RE: **ADDENDUM NO. 1**

RE: ADDENDUM #1

Changes to Issue for Bid Documents Dated February 19th, 2026

PROJECT: RPS Project 2602 Carlson Elementary School Additions & Renovations

1 FLOOR PLAN - REVISED - LIFE SAFETY PLAN
SCALE: 1/16" = 1'-0"

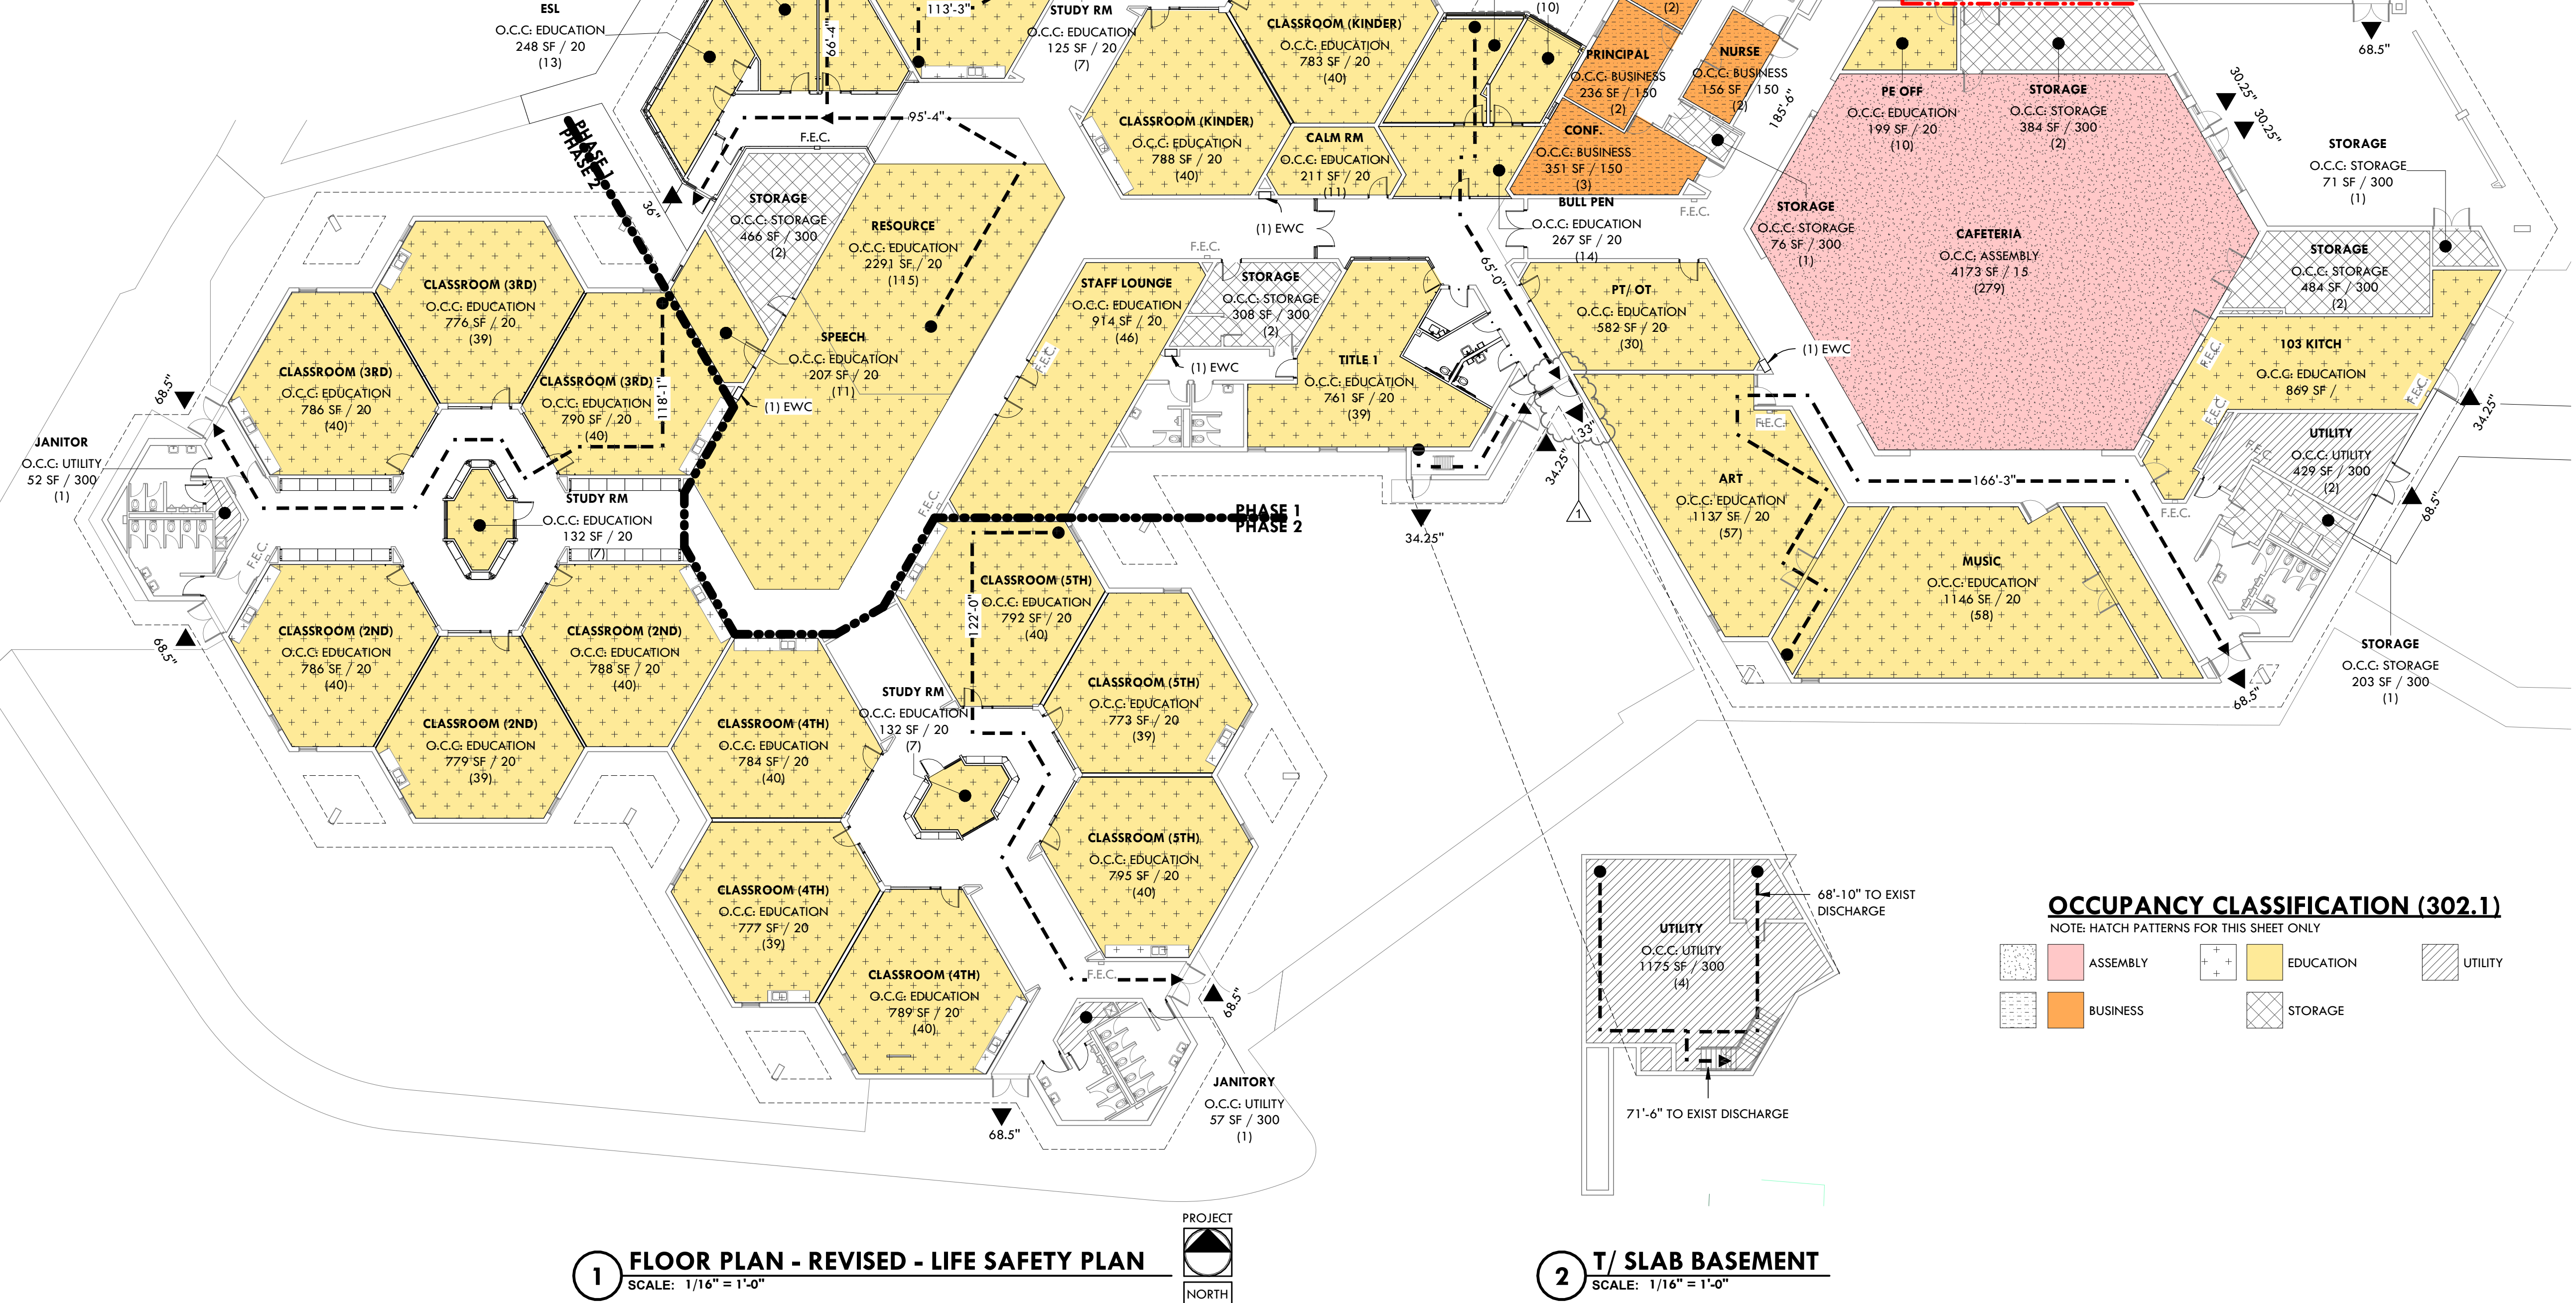
- A. Exterior door 126.1.1 and storefront 126.A have been added to the project.

1 1ST FLOOR PLAN - DEMOLITION
SCALE: 3/32" = 1'-0"

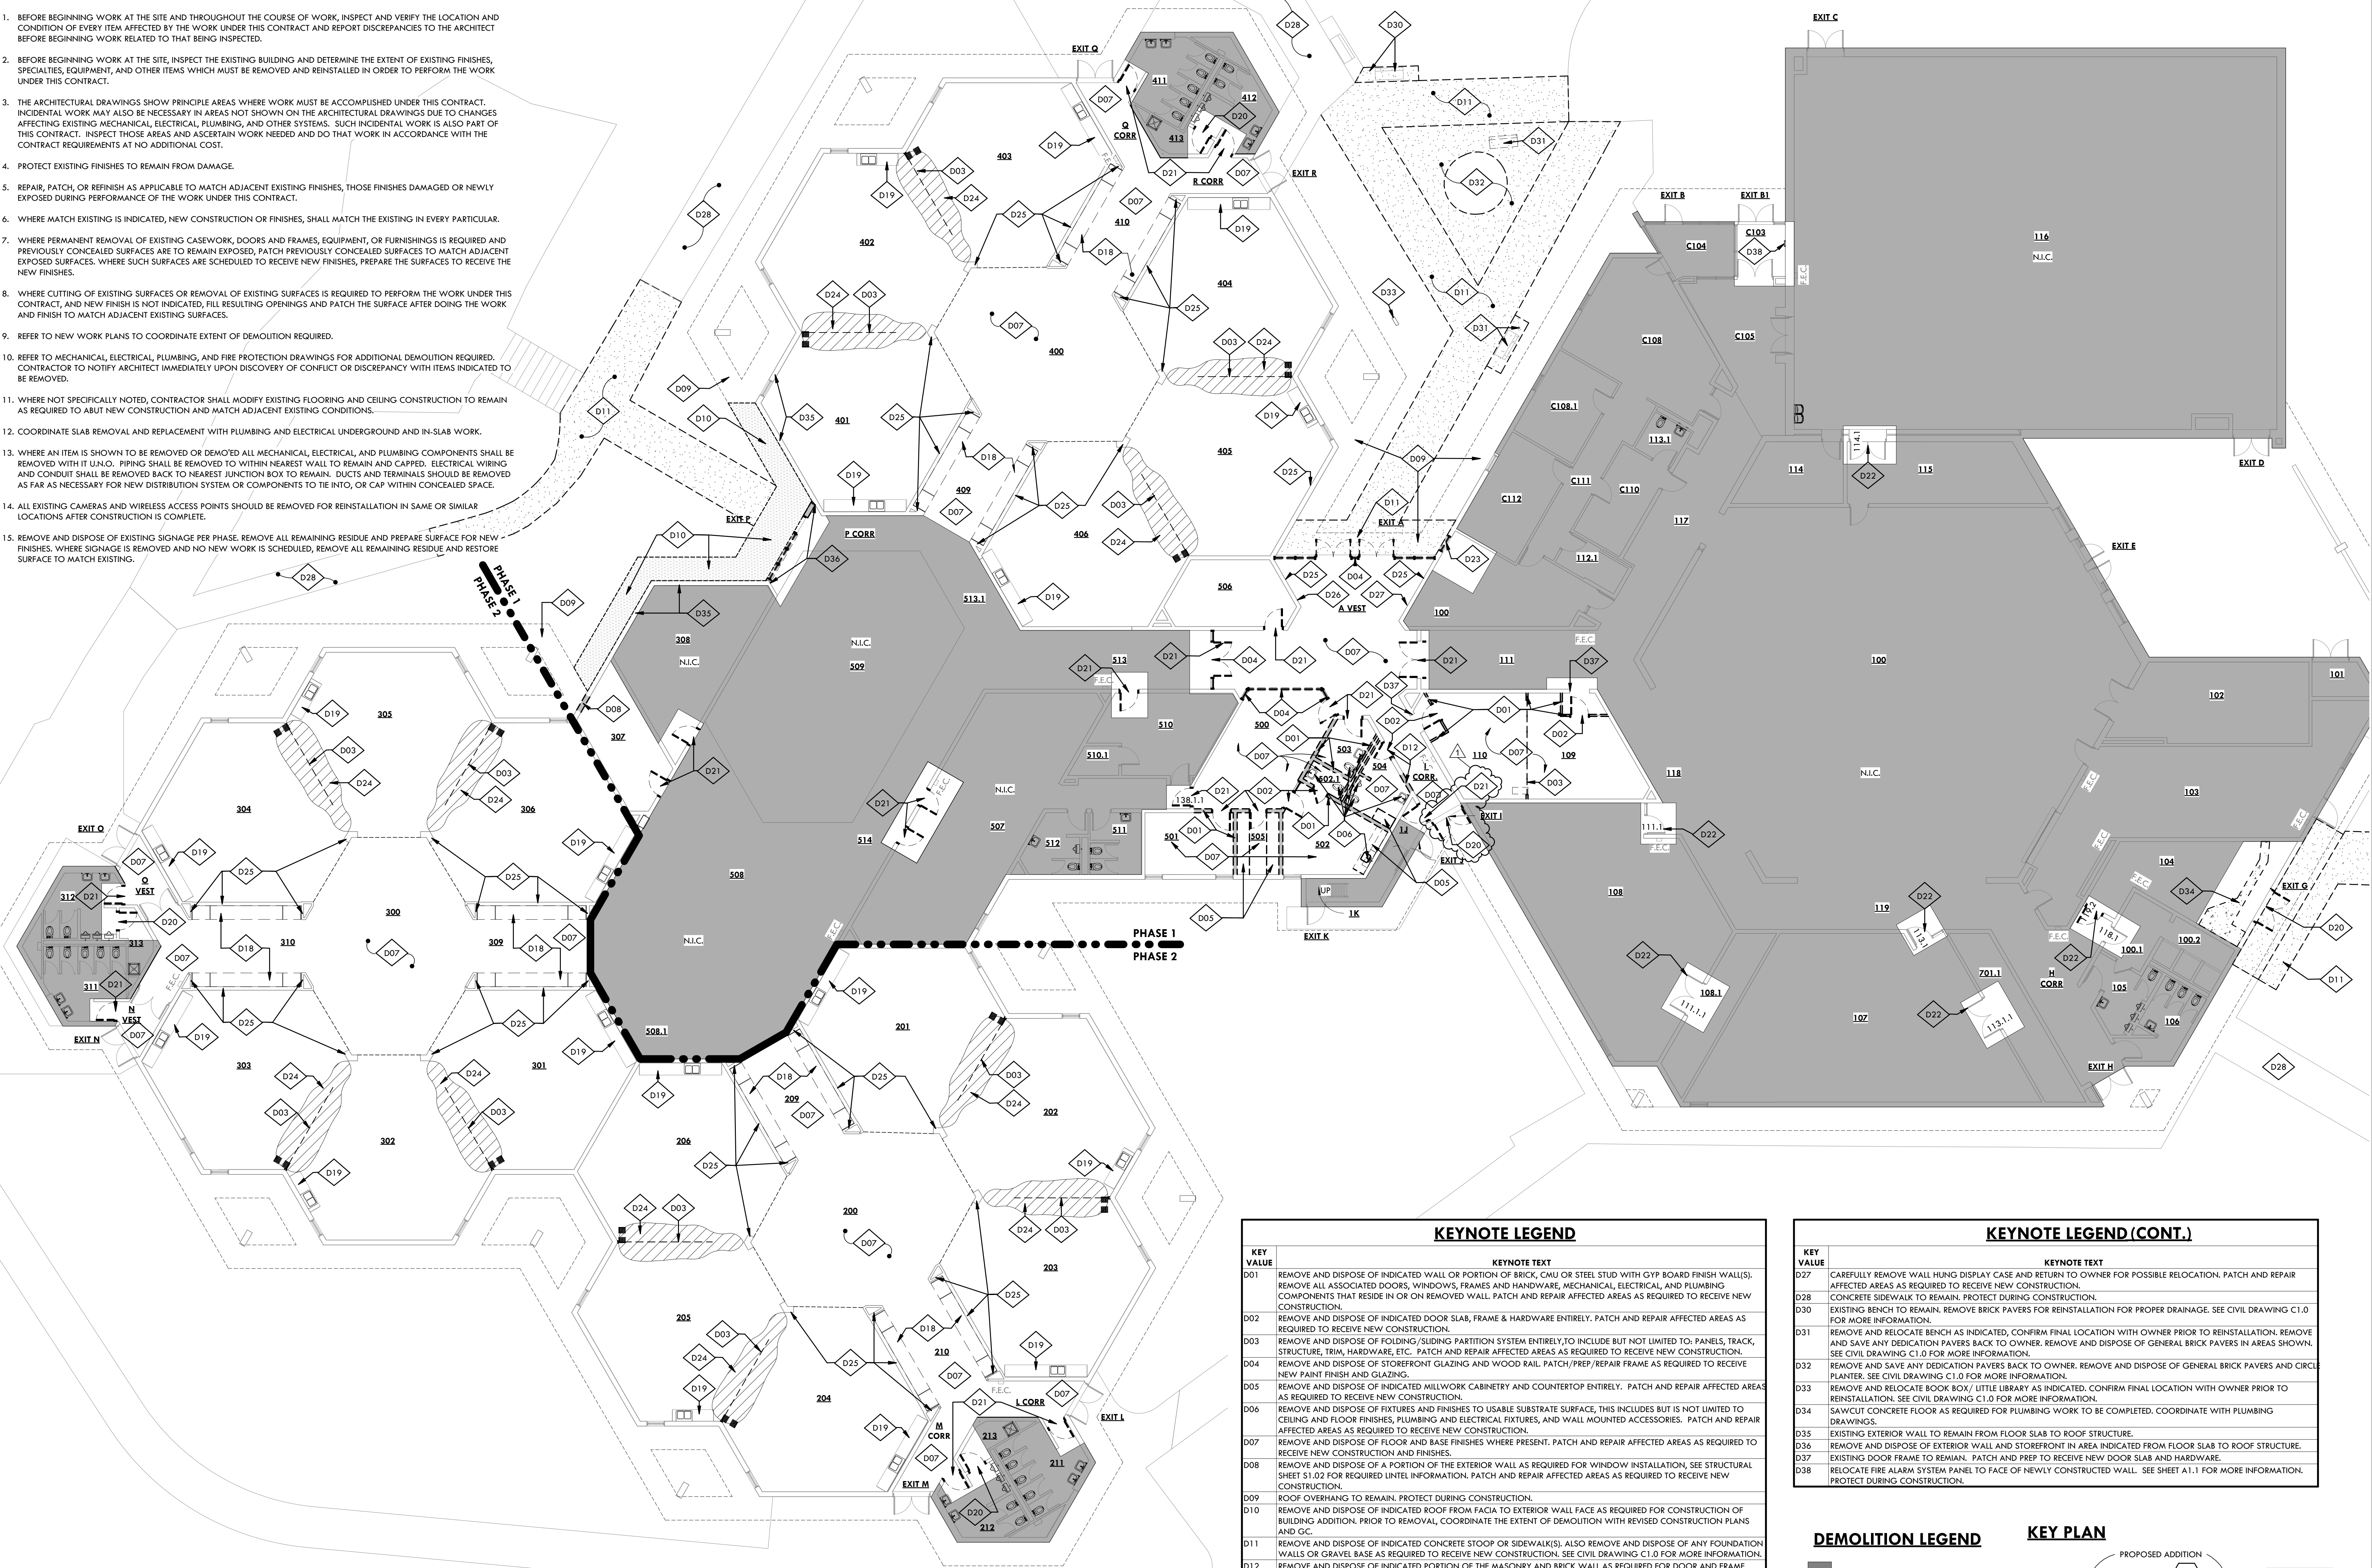
- A. The exterior door pair, hardware, and frame at 'I' Corridor will be removed. The remaining masonry opening should be patched and repaired to receive new construction.

1 1ST FLOOR PLAN
SCALE: 3/32" = 1'-0"

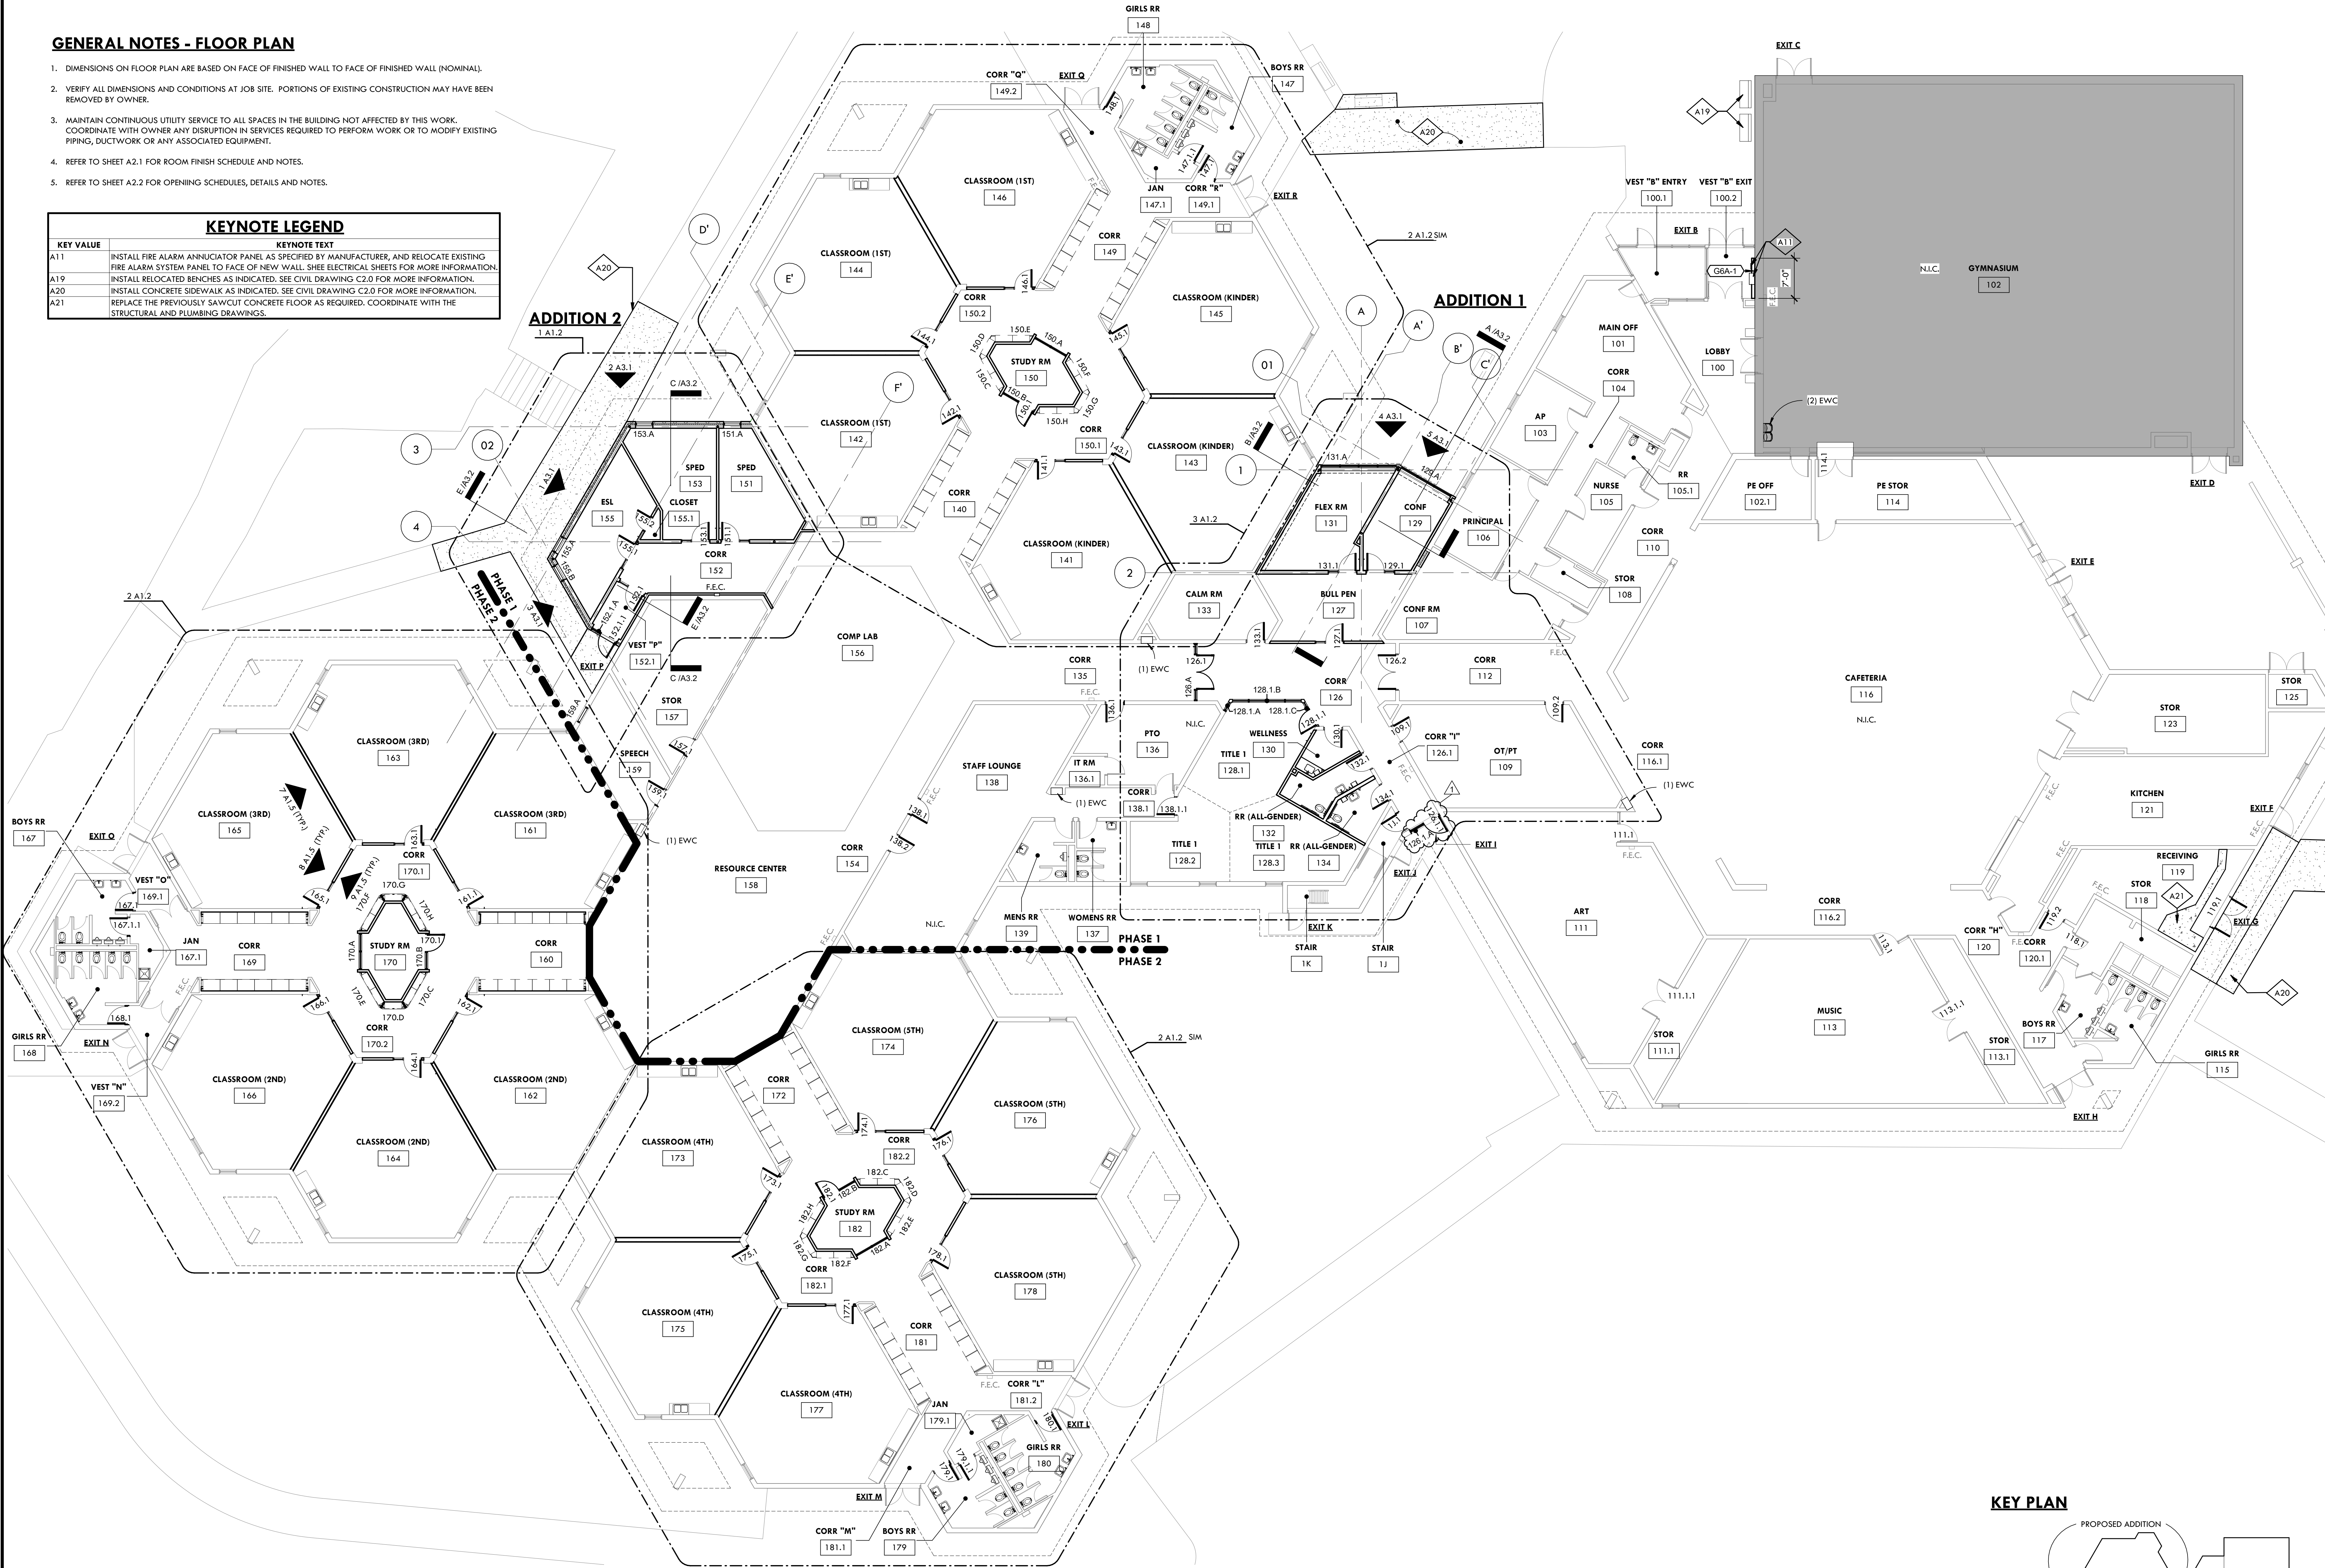
- B. Exterior door 126.1.1 and storefront 126.A have been added to the project.
